The 136th Meeting of State Level Expert Appraisal Committee - 1 held on 5th, 6th & 7th October, 2016 at Parishad Sabhagraha, Hall no. 3 & 4, 7th Floor, Main Building, Mantralaya, Mumbai- 400 032.

1	*	Confirmation of minutes of 135th meeting
	l "	Continuation of influence of 125 meeting
- 1	\

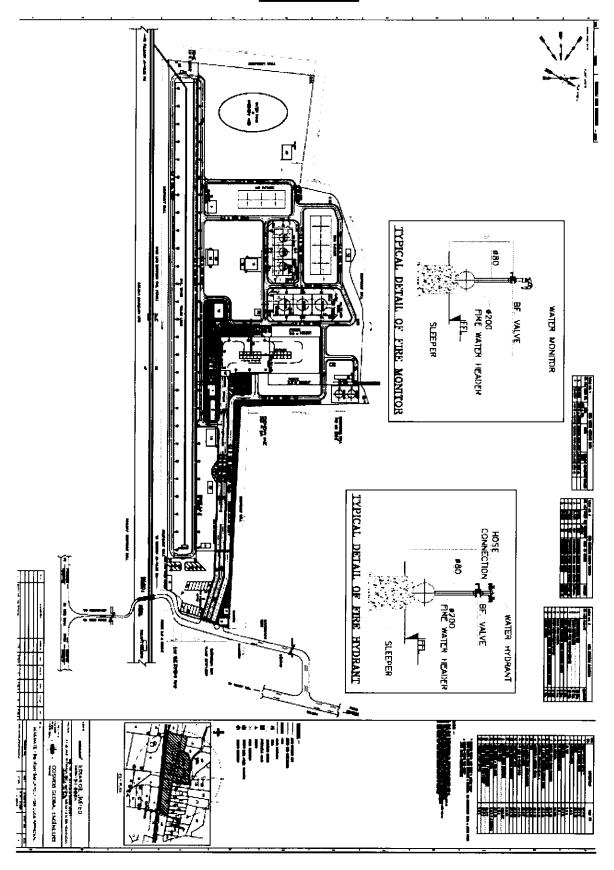
- 7. Risk Assessment and Risk Mitigation Studies were carried out. There is a contingency of off-site emergency, hence hazard management plan shall be shared with the District Administration. Diagram enclosed in the *Annexure 13.1* gives the layout of the plot with the all hazard management facilities. Maharashtra Pollution Control Board (MPCB) should verify the provision of these facilities before granting Consent to Operate.

"Annexure 23.3"

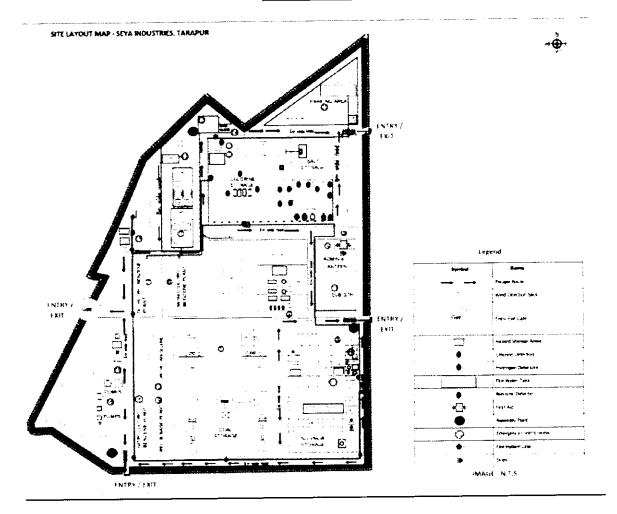
- 8. PP has done an elaborate study on Risk Assessment and Risk Mitigation. *Annexure* 23.3 gives layout diagram for various hazard management facilities. MPCB should verify this before granting Consent to Operate. Workers should be physically analyzed for Benzene metabolites at regular intervals. PP shall establish online monitoring of Benzene.

"Annexure 27.1"

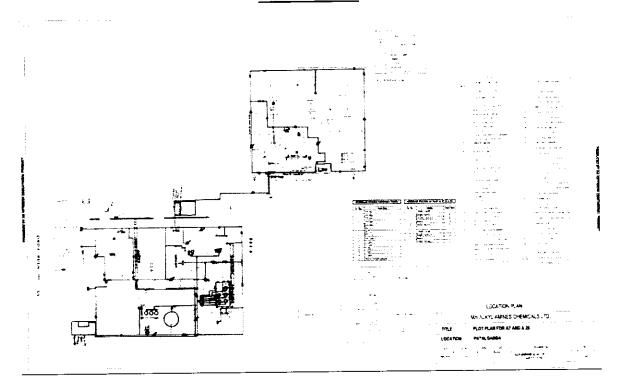
- 1. Annexure 27.1 gives details of hazard management facility that PP will provide. There is a contingency of off-site emergency, hence hazard management plan shall be shared with the District Administration.
- 2. ETP should be revamped to achieve a TAN (Total Ammonical Nitrogen) level of <50 mg/lit.
